Town of Kittery Maine Planning Board Meeting March 12, 2020

ITEM 1 - 50 Chauncey Creek Road - Shoreland Development Plan Amendment

DRAWING No: 12601_SITE_REV_FEB27

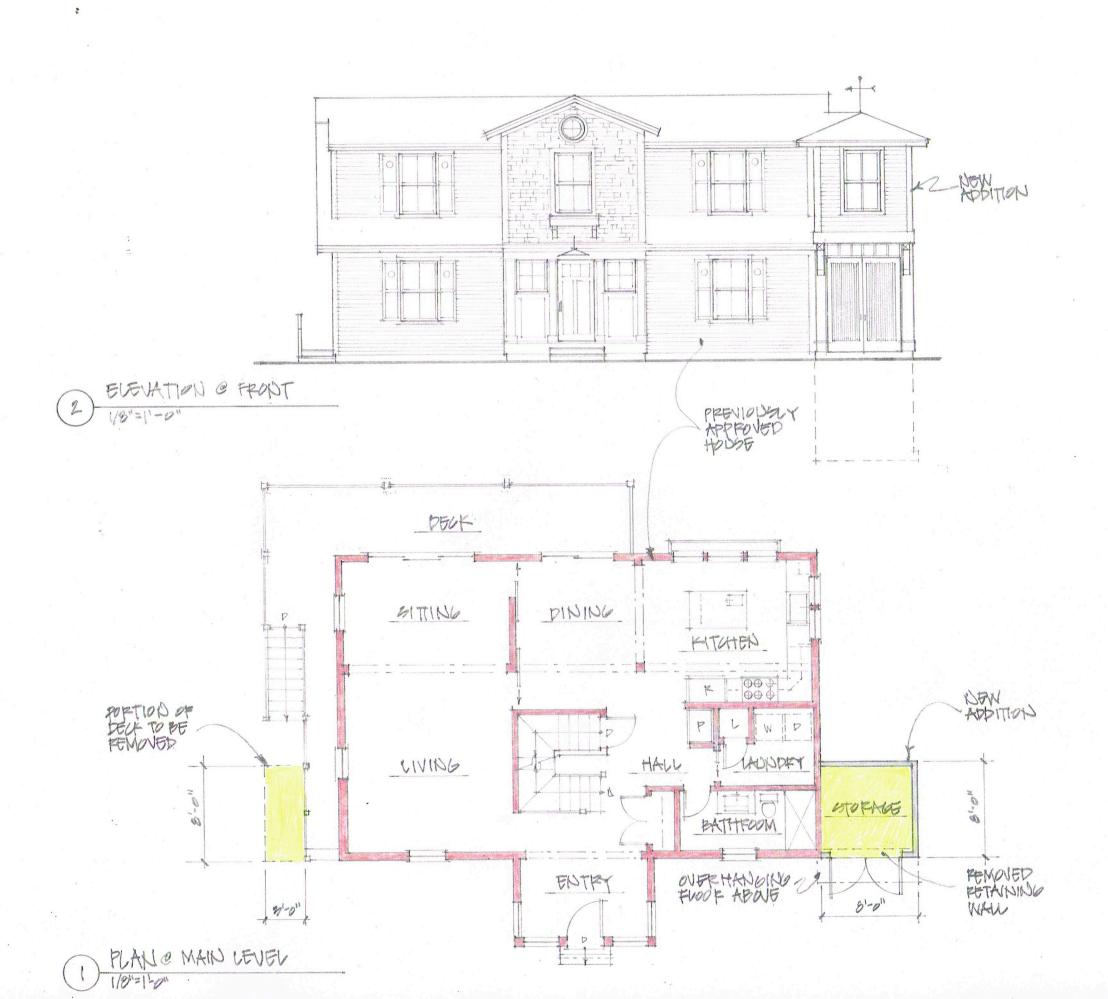
- 1. Expand the deck (labeled Approved Deck #1 To Be Reduced on the plan) by 46 sf instead of the previously approved 76 sf.;
- 2. Remove the previously approved Grass/Stone Walkway #2 from consideration;
- 3. Retain the previously approved grass/stone walkway in front (Approved Walkway #1) + step (Step);
- 4. Remove the previously approved Stairs #2 from consideration;
- 5. Retain the previously approved Stairs #1;
- 6. Retain the previously approved Retaining Wall #4; and
- 7. Add an 80 sf two story addition (Proposed Addition) to the house.

The de-vegetated area percentage -24.2% – will remain the same as the previously approved plan. Building coverage will be 15.3% which remains under the maximum allowed (20%).

The building expansion involves adding an 80-sf addition on the northwestern side of the house with storage on the ground level (accessible from the street-side of the addition) and living space on the second floor while staying within the required 15-foot side yard setbacks. The previously approved retaining wall will be located underneath the building expansion.

The proposed expansion does not meet the requirements of the Shoreland Zone (OZ-SL-250') since the entire property lies within the 100-foot setback. Article III Nonconformance must be examined.

- 1. Subsection 16.7.3.3.B(3)(e)[3] states "Expansion of any portion of a structure that is located within the 25 feet of the normal high-water lie of a water body, tributary stream, or upland edge of a coastal or freshwater wetland is prohibited even if the expansion will not increase the nonconformity with the water body, tributary stream, or wetland setback requirement." The addition as proposed sits outside the 25-foot setback shown on the plan so this subsection does not apply.

The addition as proposed does not exceed the 30% larger expansion limit (1,115 sf originally, 1,195 sf proposed which is about a 9% expansion). The height of the proposed addition is not as tall as the approved height (23 feet, 4 3/4 inches) of the structure being rebuilt. The proposed weathervane is not considered a structure.

Move to accept the application as complete and approve the Shoreland Development Plan amendment, dated 2/27/20, from owners/applicants, Thomas and Michele Jordan, to add an 80 sf addition to a 1,115 sf residence and make associated site improvements to a 7,800 +/- square foot parcel located at 50 Chauncey Creek Road (Tax Map 44 Lot 59) in the Residential Kittery Point Village (R-KPV), Shoreland Overlay (OZ-SL-250') and Resource Protection (OZ-RP) zones with the condition that the site plan be dated February 27, 2020 as the application is.
